Groundwater Application Review Summary Form

Application # G- 18441

TO: Water Rights Section Date July 27, 2017
 FROM: Groundwater Section Michael Thoma
 Reviewer's Name
 SUBJECT: Application G- 18441 Supersedes review of _____
 Date of Review(s) _____

A. GENERAL INFORMATION: Applicant's Name: Robert and Janet Bothwell County: Jackson

Water-Level Trends in Nearby Wells

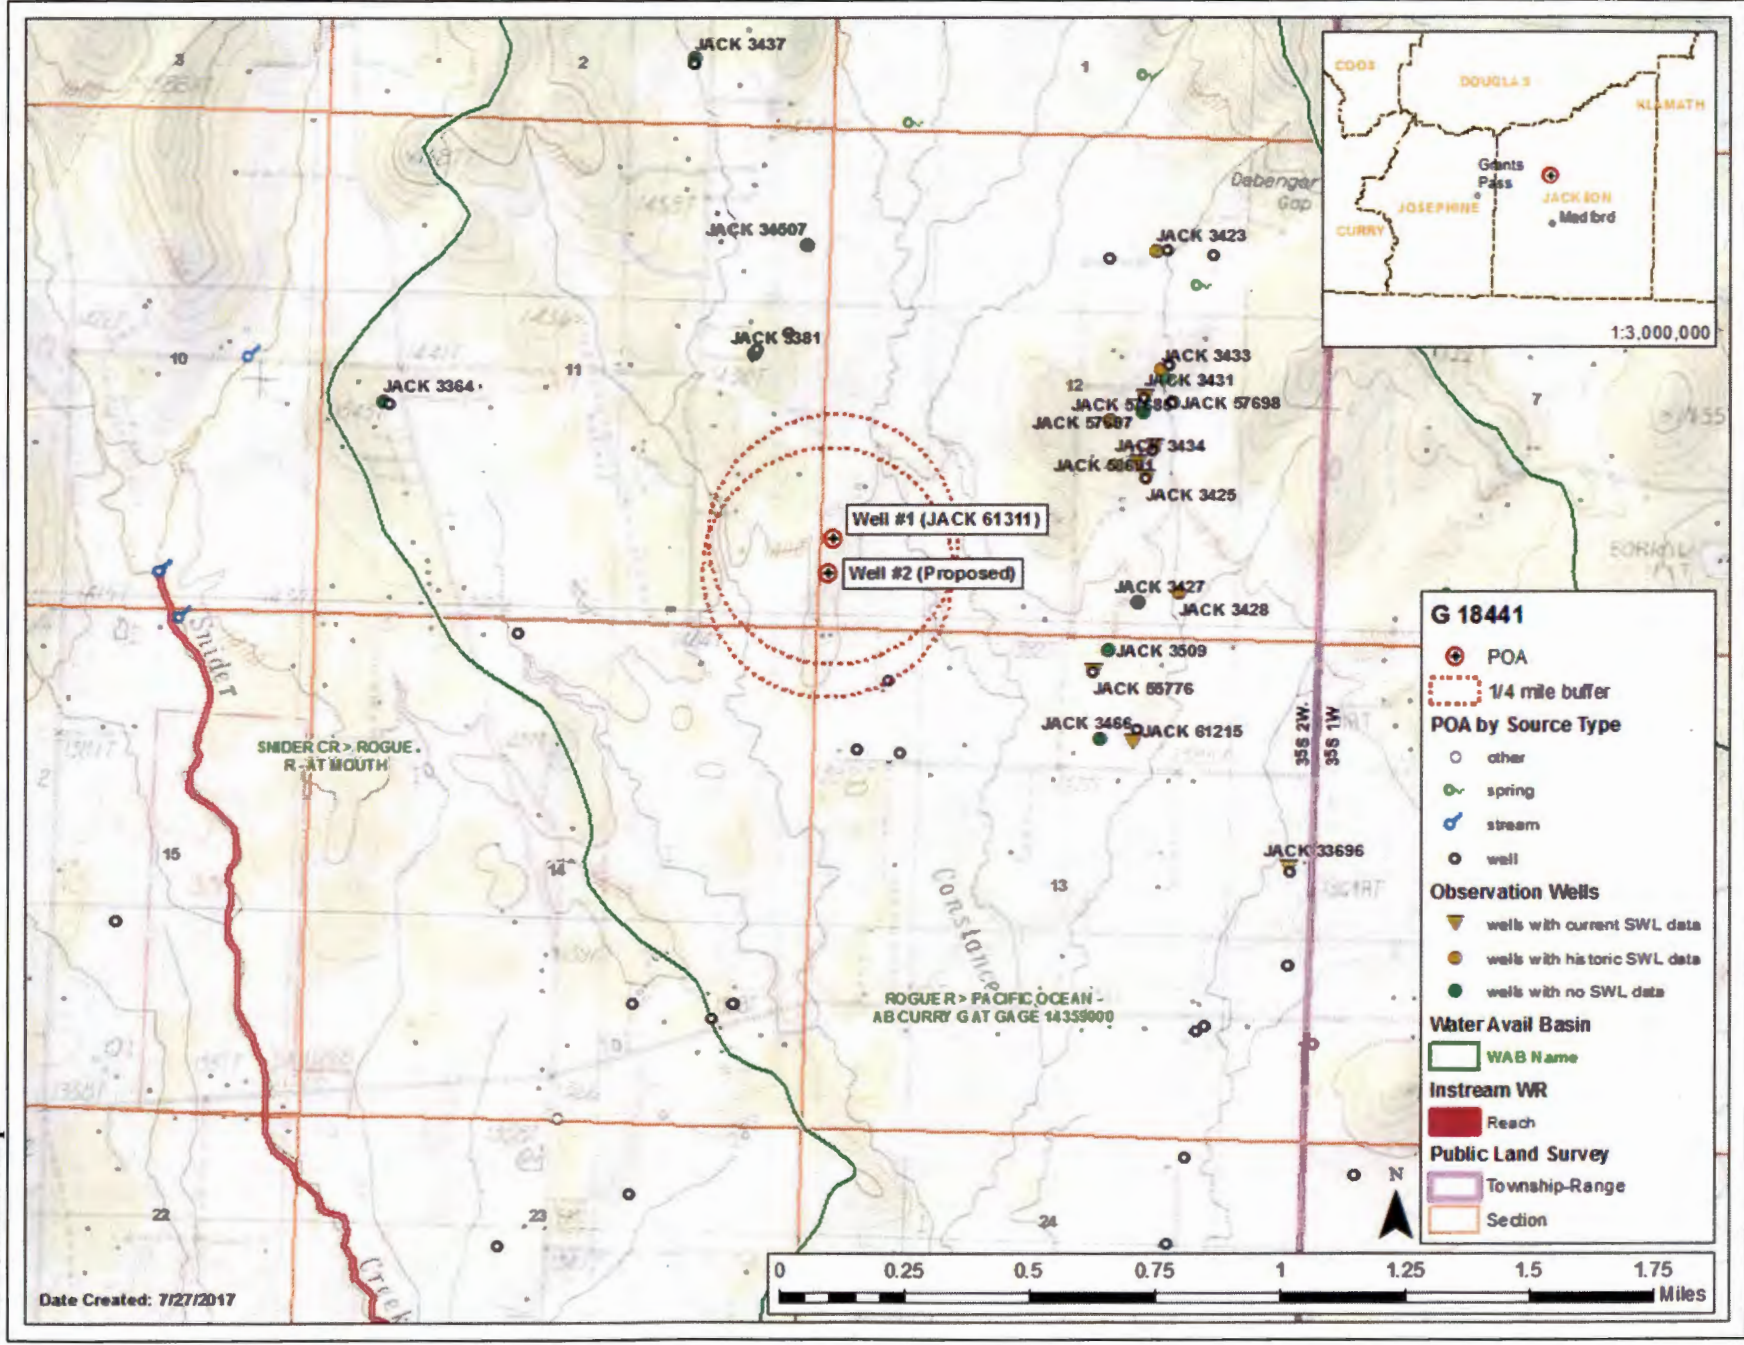
- B3. **Groundwater availability remarks:** There are several wells in the area of the proposed POA that have water-level data over the past decade. These data show a stable trend which implies that groundwater is not currently over-appropriated in the area. There are numerous permitted groundwater POAs scattered throughout the area of the proposed POAs (approx. 20 within 1 mile, the nearest being just over ¼ mile from Well #2) so there is potential for injury to existing permitted and thus conditions described in B1(d) are recommended on any permit that results from this review.
- _____
- _____
- _____

Stream-depletion Model Results

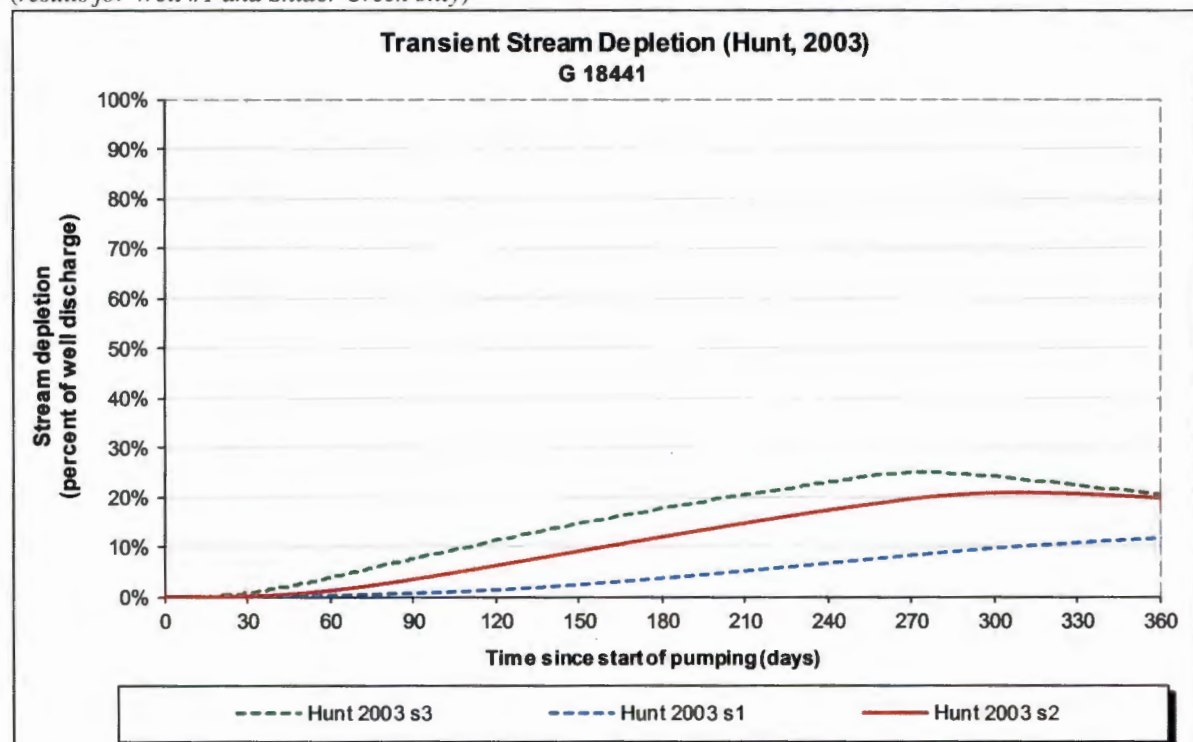
Basis for impact evaluation: Impacts to surface waters were evaluated for the nearest well to the WAB with the smallest monthly flows (i.e., maximum impacts), in this case Well #1 to Snider Creek. Stream depletion was estimated using the Hunt (2003) stream-depletion model with aquifer parameters that are representative of a fractured bedrock aquifer overlain by medium-to-coarse alluvial or weathered bedrock material. Model results are presented in Section E

- C6. **SW / GW Remarks and Conditions:** The applicant's proposed POAs would be producing from an aquifer that has been found to be hydraulically connected to surface waters Constance Creek and Snider Creek at distances of > 1 mile. The estimated interference to streamflow (stream depletion) was calculated to be > 1% of one or more of the monthly 80%-exceedance natural flows so there is a preponderance of evidence to require the Department to assume that the proposed use will have the Potential for Substantial Interference with surface water. If the requested rate were reduced below 0.05 cfs (22 gal/min) then PSI would not be assumed for this review.
